RE: Site Inspection; U. S. Energy, Frank M and Tony M Mines,
M/017/001 and S/017/017, Garfield County, Utah

Purpose of Inspection:

**ATTACHMENT
Photographs**

**M/017/001 and S/017/017, Frank M and Tony M Mines, U. S. Energy
Inspection Dated: January 29, 2004; Report Dated: February 4, 2004**

Photo 1. The breach in the dam for the mine water impoundment.

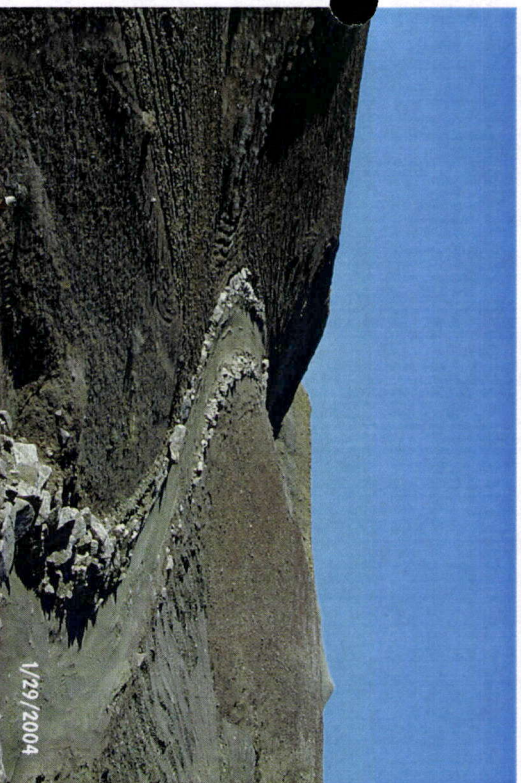
The road leading to the impoundment had been ripped and seeded. The dam was breached, and large rocks from the inside of the dam were placed on the first part of the resulting channel through the dam (Photo 1). A more traditional riprapped channel was created where this channel begins to drop more steeply (Photo 2).

breached, I believe it is unlikely the pond will discharge in the foreseeable future. If discharge was likely, I would be concerned about the lack of graded material in the channel through the breach. If there was flow, it would tend to erode the clay around the large rocks.

Photo 4. The cut on the hill above the mine water impoundment. The water line used to be in this cut.

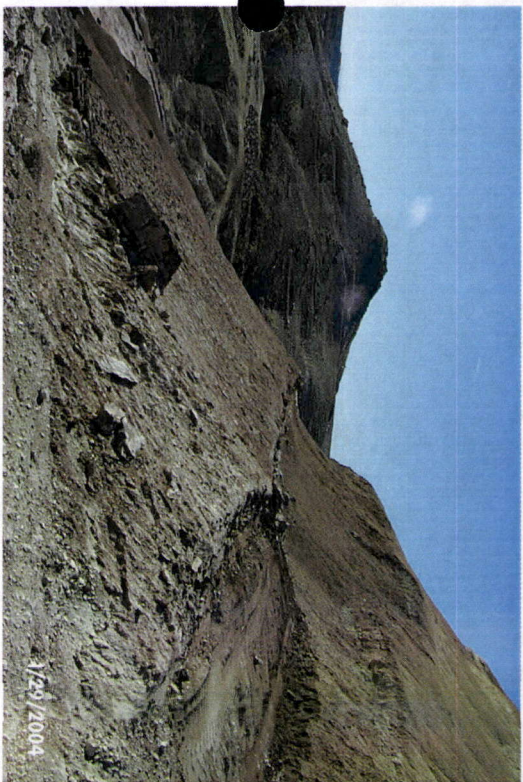
During operations, water was piped from the mine to the pond through a pipeline laid in a cut on the clay slopes above the impoundment (Photo 4). The operator did not backfill this cut and does not intend to do so. We hiked up to this area to view it more closely, and although the cut looks large from below, a lot of material has sloughed into it (Photo 5). There is not much of a cut left, and over time, it will probably disappear altogether.

Photo 9. Near the center of this picture is a berm that directs water away from the road leading to the escapeway.

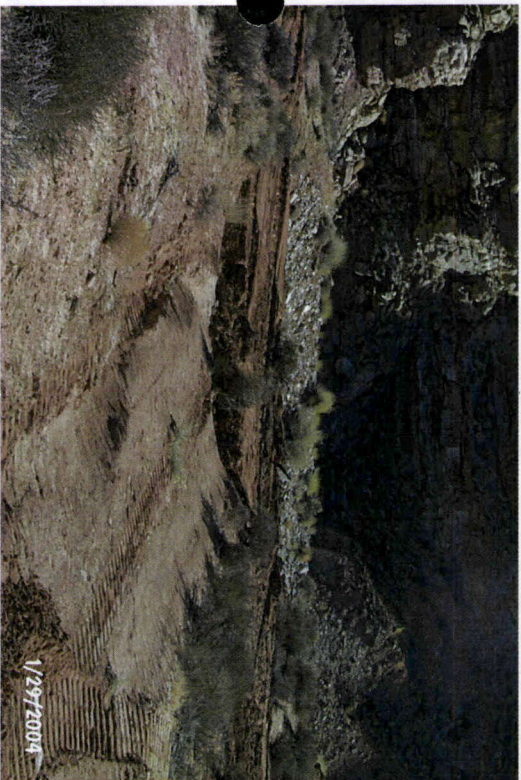
could be some erosion problems. During an inspection in November, the operator was advised to put a berm at the top of the road to direct water to the side and away from the road. This had been done (Photo 9).

Photo 10. Waste pile at the main mine area. Note the terraces.

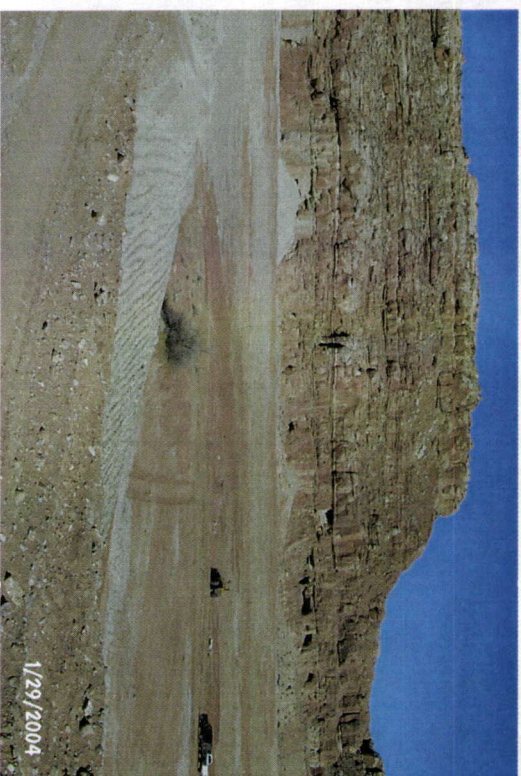
The waste pile in front of the main mine area (Photos 10 and 11) was graded so there are three terraces. The uppermost of these was the mine pad, and it was being ripped during the inspection. Runoff from above the mine would be caught on this terrace and channeled toward the south. Mr. Craft indicated water would then go into some abandoned portals. The other terraces are designed to decrease the slope length, and one takes water to the north and the other to the south.

Material used as soil varies from very sandy to somewhat clayey. Probably the least desirable substitute soil is in the waste pile at the main mine area. It appears to be a clayey sand or sandy clay. The test plots shown in Photos 14 and 15 are probably a good representation of the potential vegetation cover in the area, and it may be possible to use them as a success standard.
